PRODUCT SUPPORT BULLETIN BULLETIN NO. 367

MACHINE: Model C, 99C and 99C-03 Spike Driver

SUBJECT: Rail Clamp Cylinder Rod Interference with Pivot Bracket

Figure 1

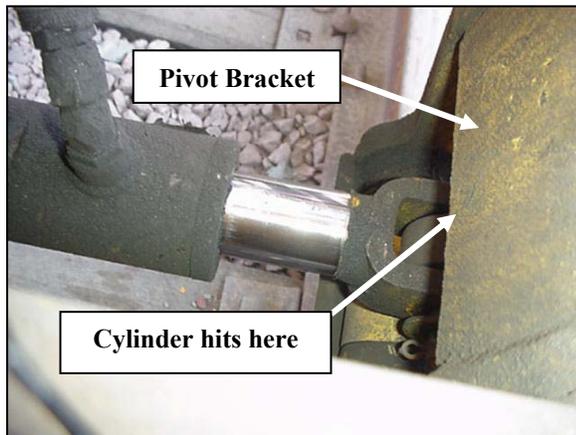
On some machines, the Clamp Cylinder Pivot Bracket may interfere with the Clamp Cylinder Rod during cylinder operation if the bushings are worn. See **Figure 1**. This interference can nick the cylinder rod and can cause a premature failure of the Cylinder Rod Seal.
